SUSPENSION
SU002-99

Title:
FRONT SUSPENSION SUPPORT NOISE

Models
'97-'00 ES 300 & '99-'00 RX 300

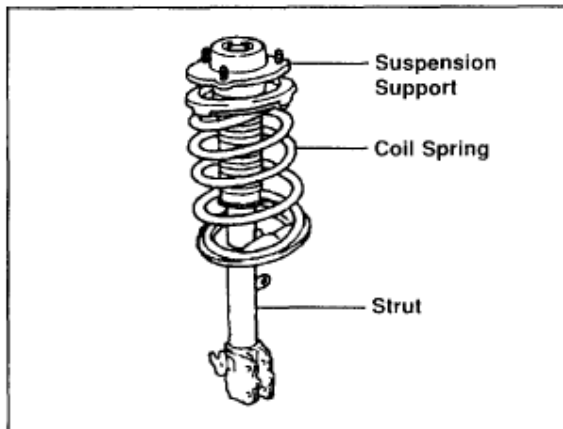
To eliminate a noise occurrence from the front suspension on washboard type road surfaces, the suspension support has been changed.

The rubber bushing shape of the suspension support has been changed.
